MGP Additional Materials

1. Dedicate Affordable Land Incentive
2. Perimeter Zone: 75 feet
3. Commercial Minimum: 25,000 sf
4. Commercial Ground Floor: 14 feet
5. Density Calculation: Include dedications
6. Internal Street Connectivity
7. Bike Circulation
8. Street Frontage Improvements
9. Internal Street Parking
10. Hotel Street Presence

MGP 1.

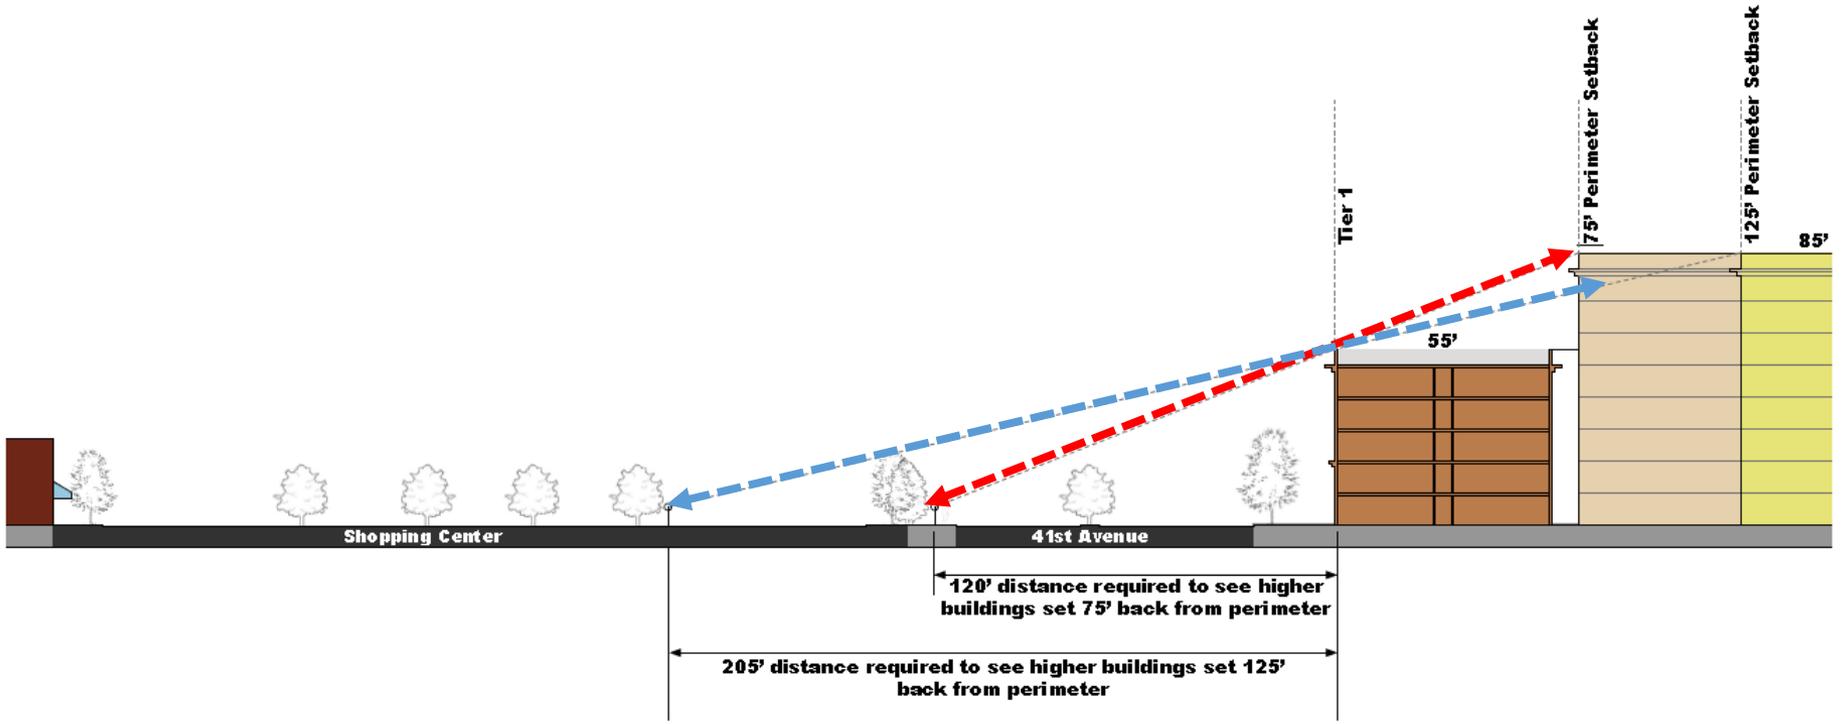
MGP: For development which includes a land dedication for the inclusionary housing requirement, request to not required deviation requirements within the project.

Staff Recommendation: Requested change not recommended. The applicant can include a density bonus application if they prefer density bonus incentives over City process.
